Memo Plan Check Revisions- New Trinity Cabin Cluster
Plan Check # B-137520

Project: New Cabins - Trinity Area
CYO McGucken Center / Camp Armstrong
2136 Bohemian Hwy.
Occidental, CA

Re: Plan Check Revisions

In response to plan check comments dated 8/1/96, the following changes have been made:

FLOOR BEAM #1

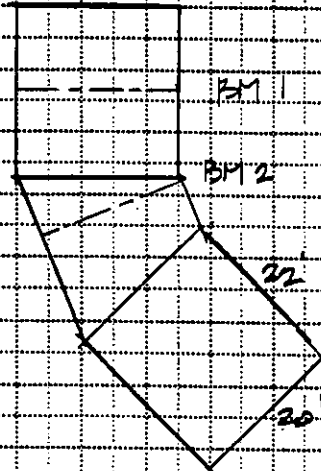
1. Structural calculations are provided to confirm existing deck structure's capacity to carry 100 psf live loads with wet use design values.
2. Structural calculations are provided to establish wind uplift loads. Clips are indicated for resisting these loads.
3. Section references are corrected.
4. Detail 4/A-4 is modified so decking is fully described.
5. Detail 5 A-5 baluster notes are modified with "4 inch sphere" wording.
6. Detail 7/A-4 is modified to reflect stair detail comments. P.T.D.F. is indicated for sleeper. Structural confirmation of notched beam is provided.
